STATE OF NORTH CAROLINA
DEPARTMENT OF TRANSPORTATION

September 30, 2025

SUBJECT: Request for Modification of the Phased Section 404 Individual Permit and Section 401 Individual Water Quality Certification for the construction of the Triangle Expressway Southeast Extension from NC-55 Bypass in Apex to I-40, Wake and Johnston Counties. TIP Nos.: R-2721, R-2828, and R-2829. Federal Aid Project No. 0540047.

We are requesting a modification to Section 404 Authorization (SAW-2019-02240) and the associated 401 Individual Water Quality Certification (Permit No. 20181249). This request is prompted by several areas changing from one wetland impact type to another (e.g. mechanized clearing to excavation) or temporary stream impacts changing to permanent stream impacts for bank stabilization purposes. Also, additional impacts are needed for a ditch tie-in at Wetland WHG, which was removed during the 4B meeting, but is being added back in as a permit site (Site 13). Details of why these changes are being made are provided below.

PERMIT DRAWING SHEET 63 OF 112

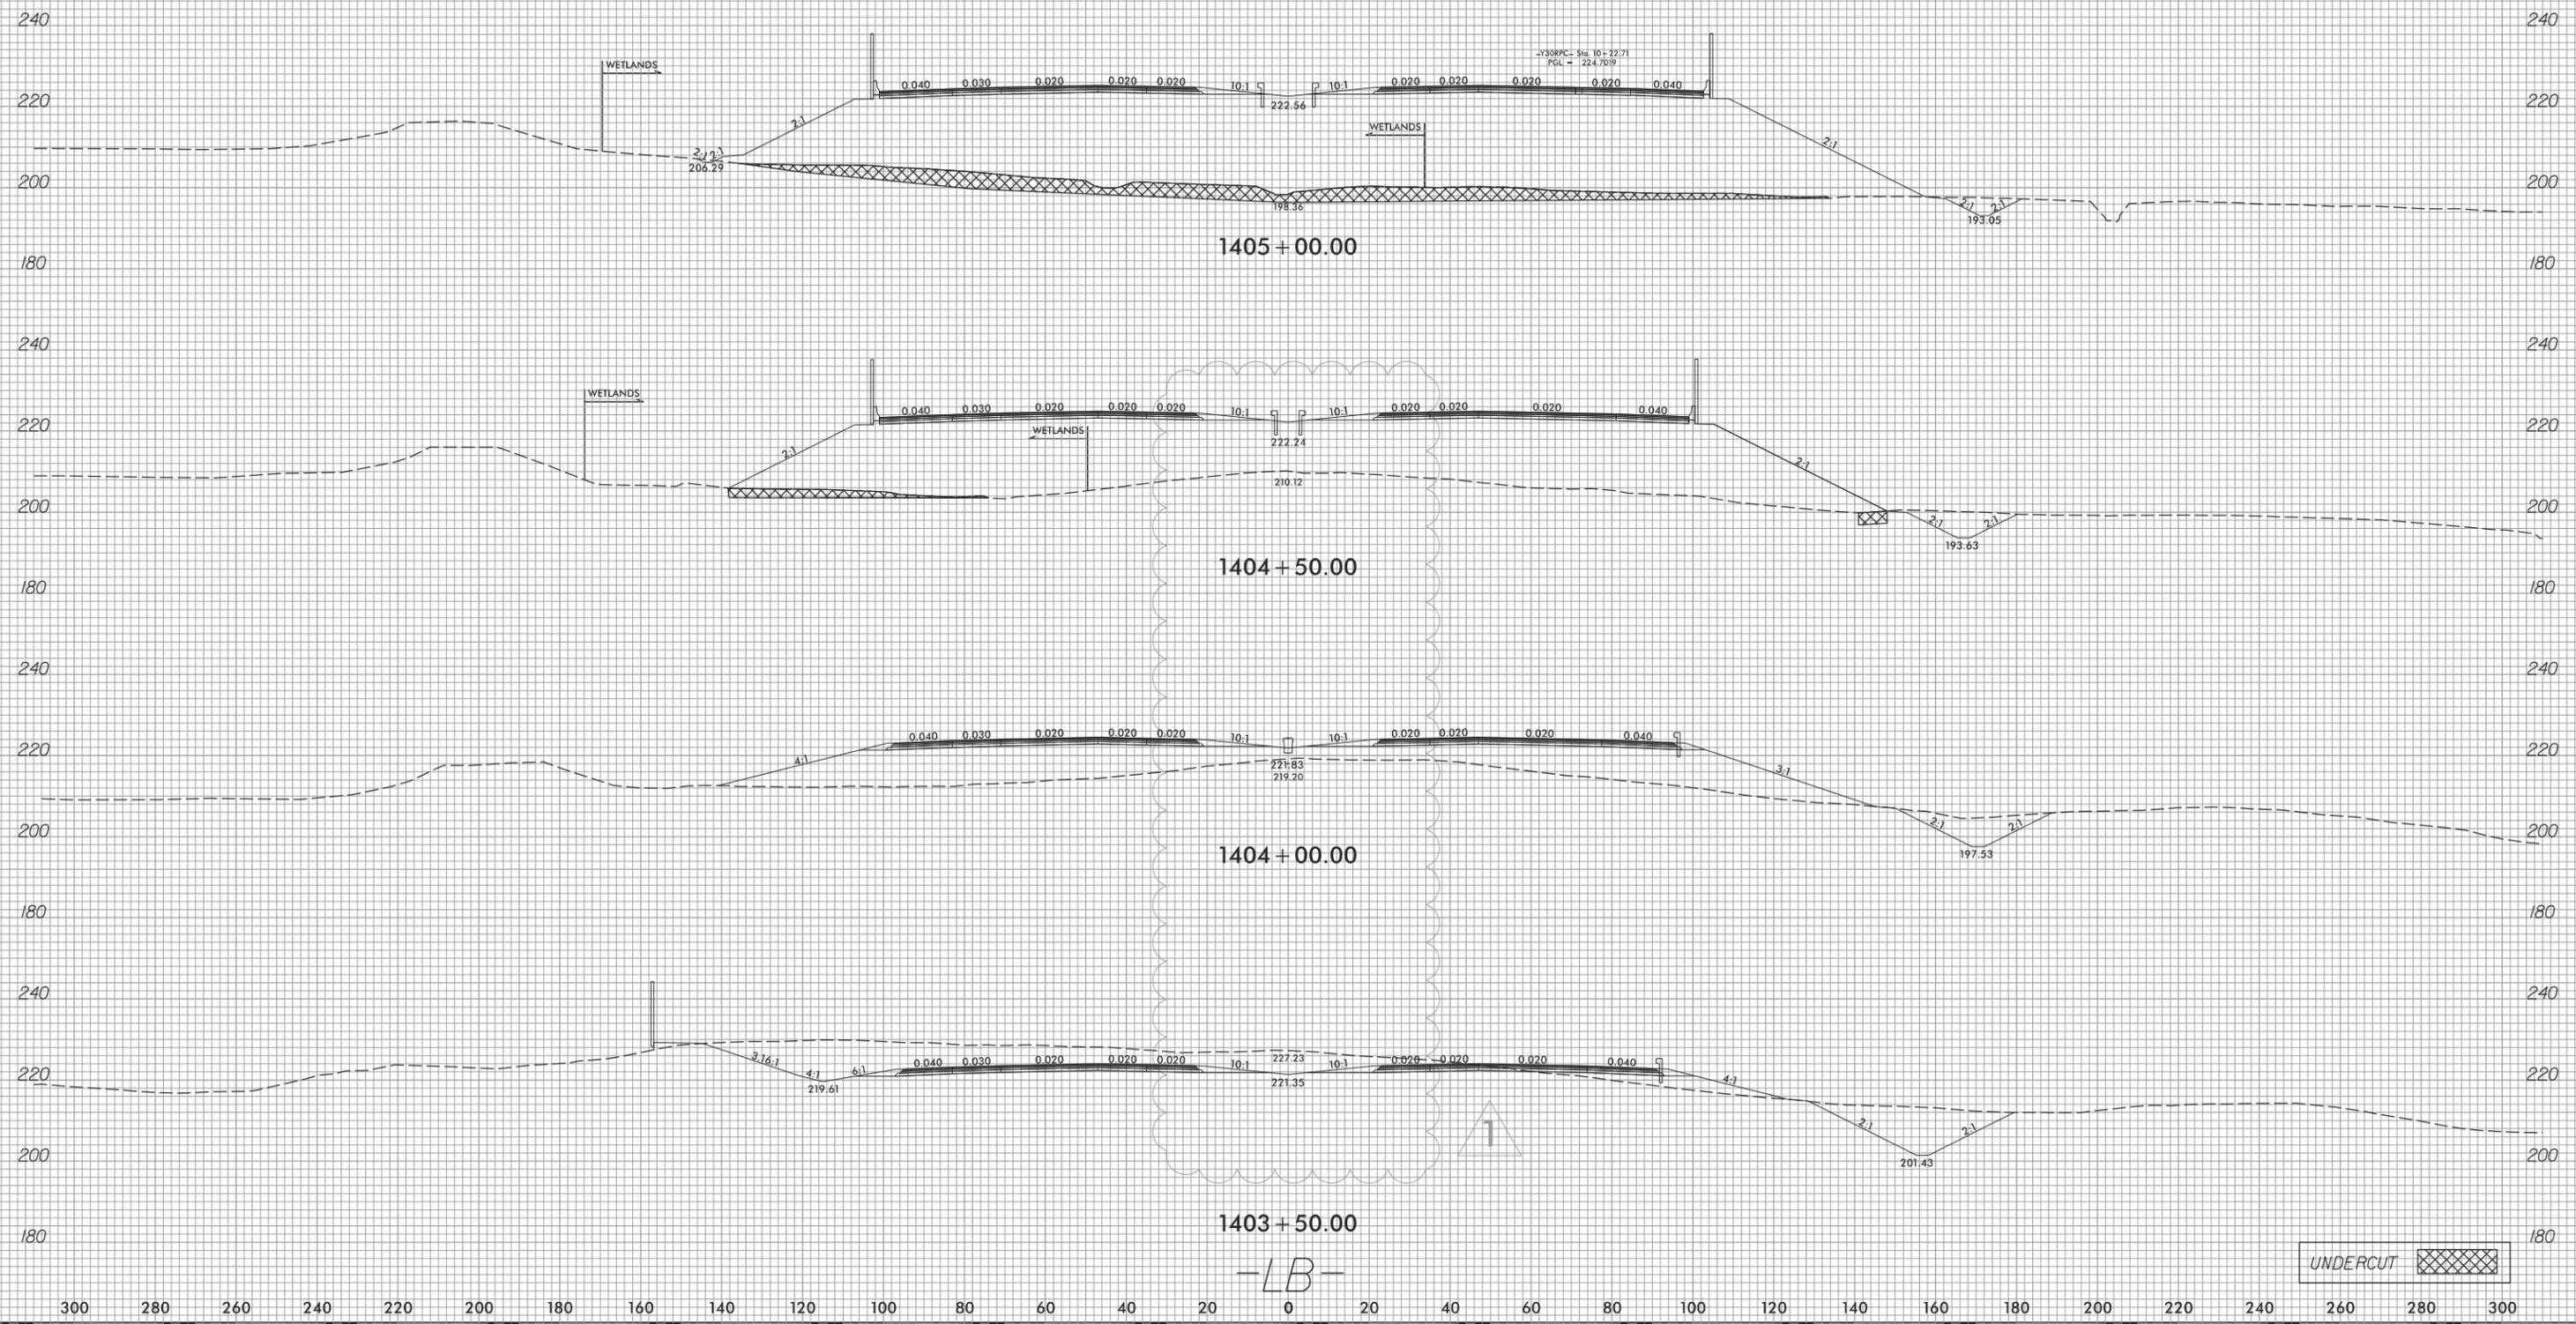
5/2/2025: -LB- STA. 1403+50 TO STA. 1404+50 & STA. 1405+50 TO STA. 1406+50 MEDIAN SLOPE REVISED TO 10:1.

SITE 24

PERMIT DRAWING SHEET 64 OF 112

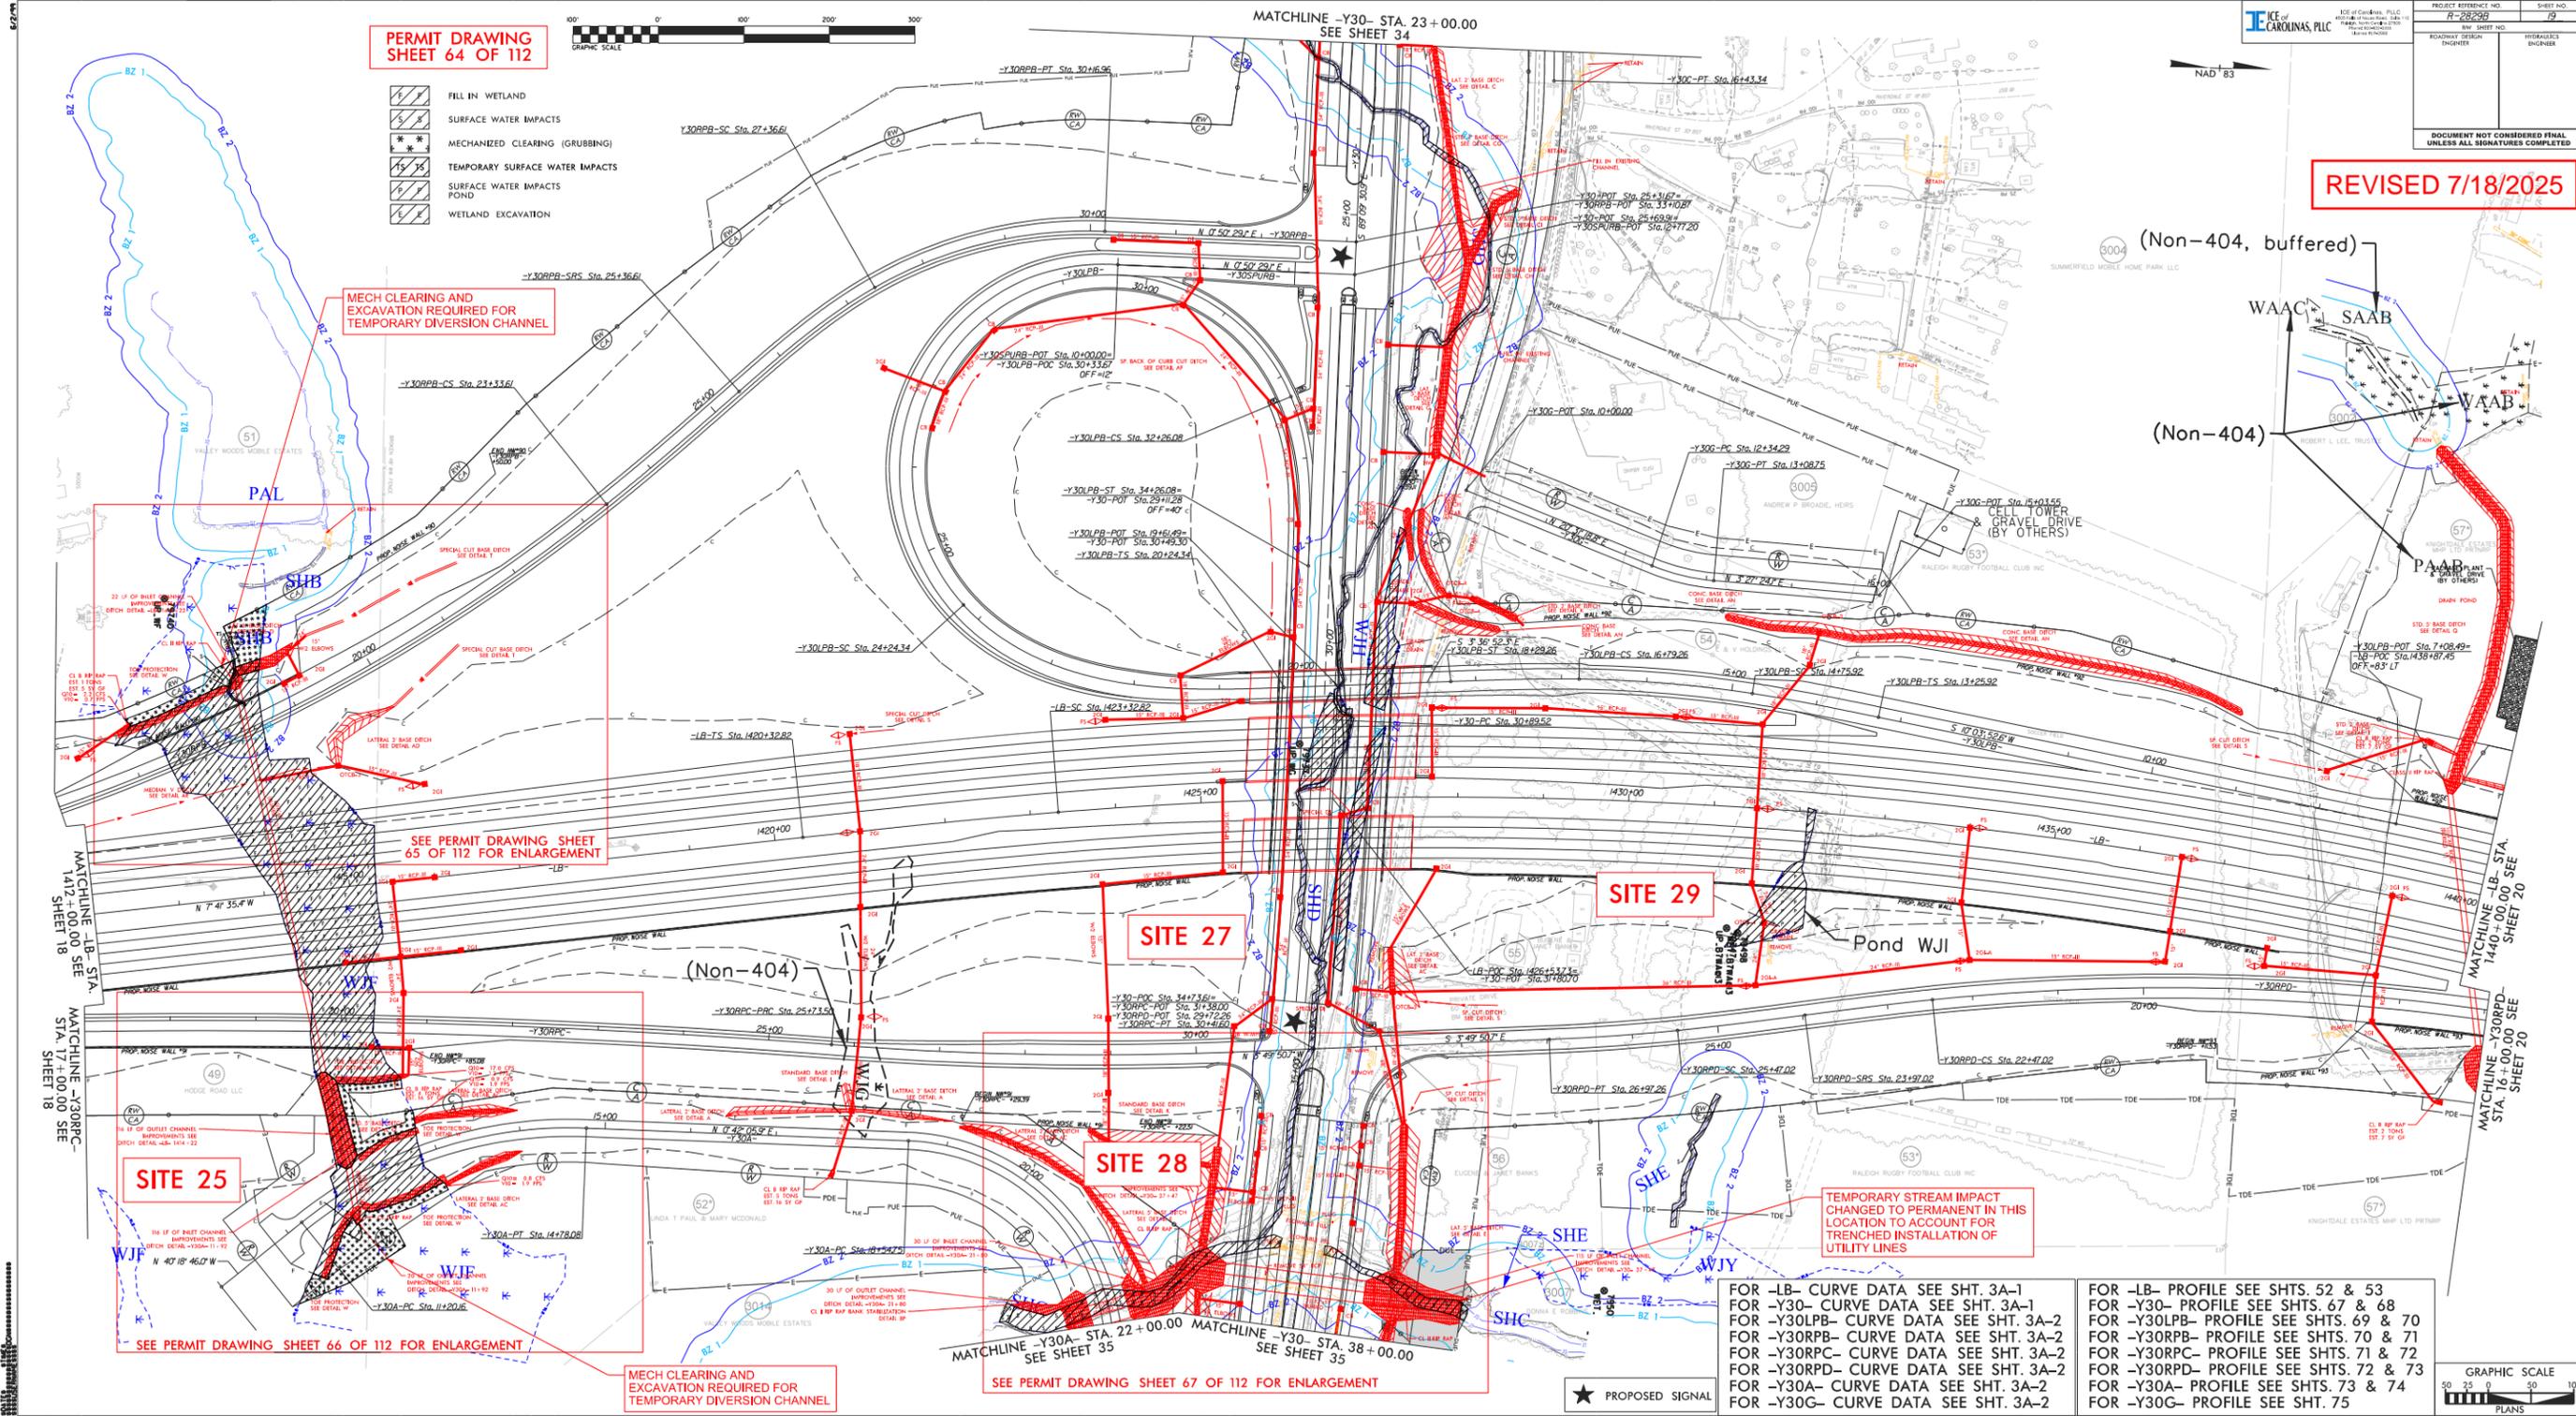
- Permanent Fill in Wetland: 0.209 ac (previously 0.207) – Increase of 0.002
- Excavation in Wetland: 0.042 ac (previously 0.034) – Increase of 0.008 ac
- Mechanized Clearing in Wetland: 0.156 ac (previously 0.166) – Decrease of 0.010 ac
- Total Mitigable Impacts: 0.407 ac (previously 0.407) – **Overall No Change**

No new impacts are required at Site 25. The actual culvert headwall/endwall’s entire footprint, including footing, has been updated in the permit drawings. The toe protection has been adjusted. For both scenarios, mechanized clearing within these areas has been converted to excavation or fill, depending on the location. In addition, a small area of Mechanized Clearing in Wetlands has been

MECH CLEARING AND EXCAVATION REQUIRED FOR TEMPORARY DIVERSION CHANNEL

TEMPORARY STREAM IMPACT CHANGED TO PERMANENT IN THIS LOCATION TO ACCOUNT FOR TRENCHED INSTALLATION OF UTILITY LINES

**PERMIT DRAWING
SHEET 69 OF 112**

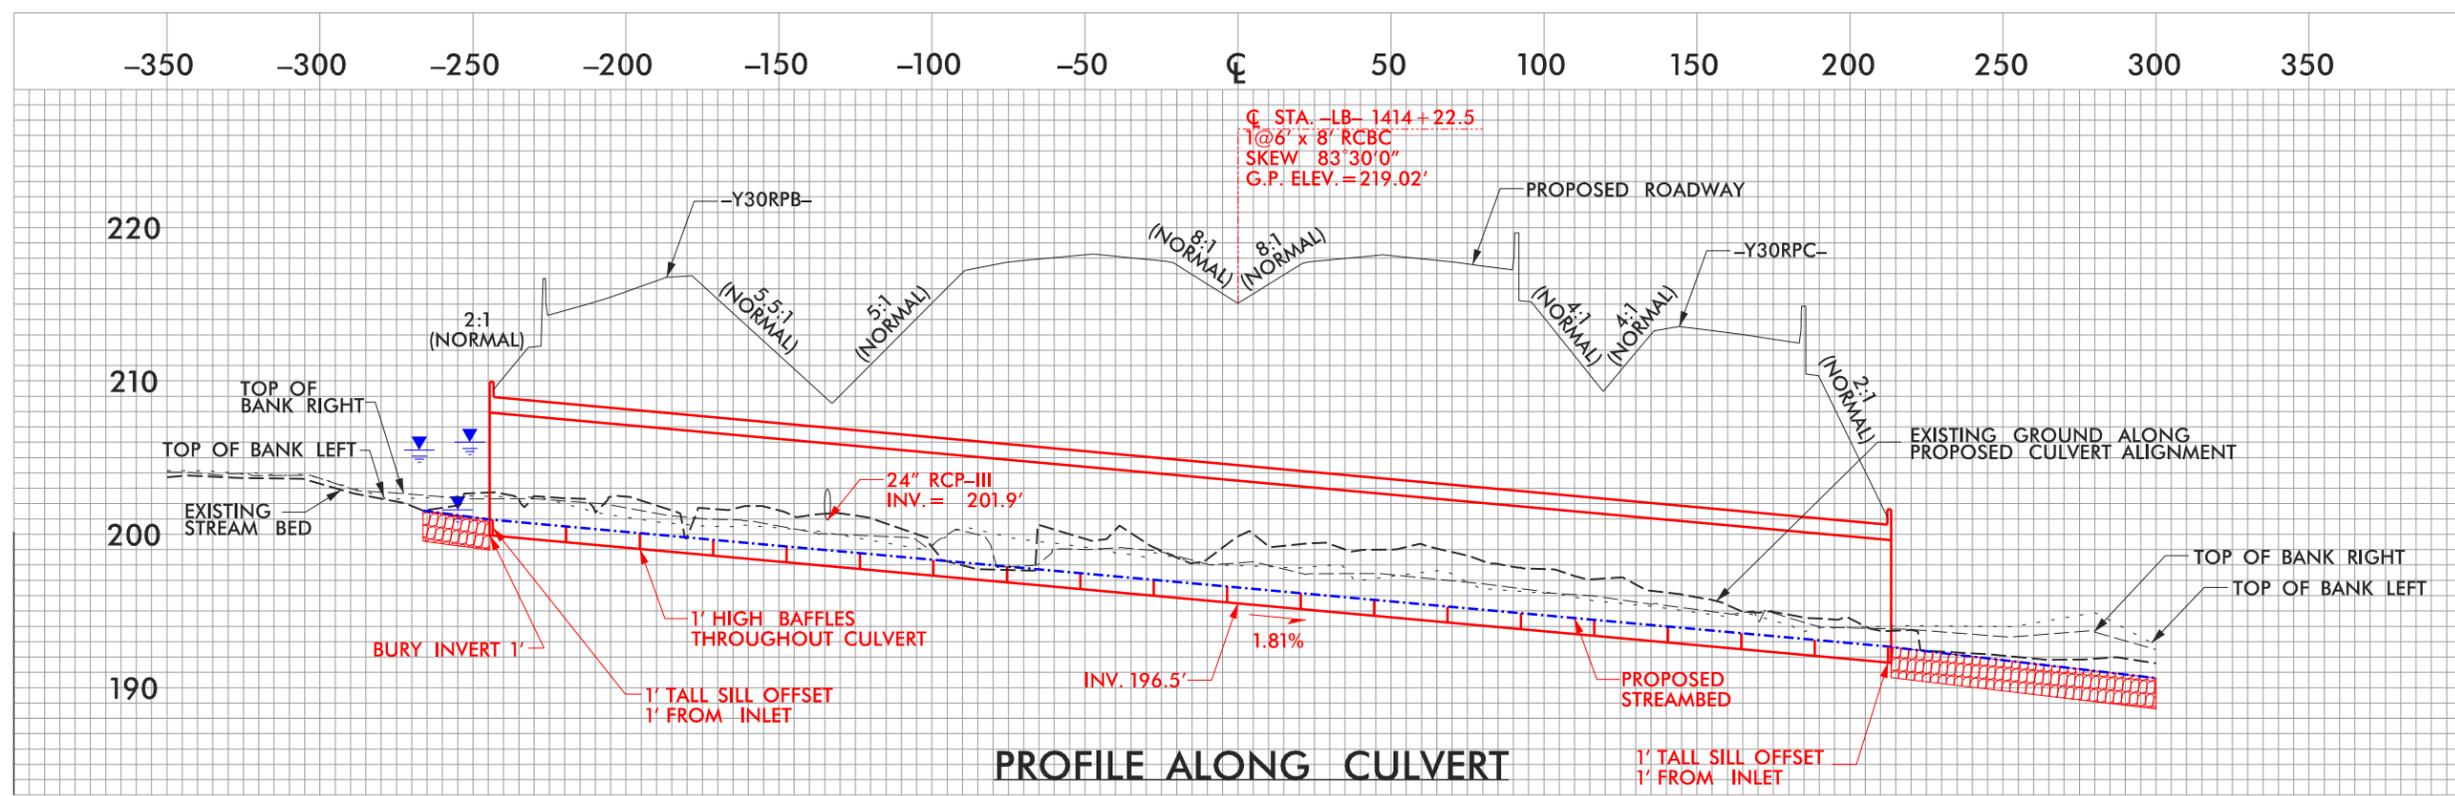
modified to Excavation in Wetlands. The planned temporary diversion has also been adjusted to better coordinate with the on-site conditions.

SITE 25
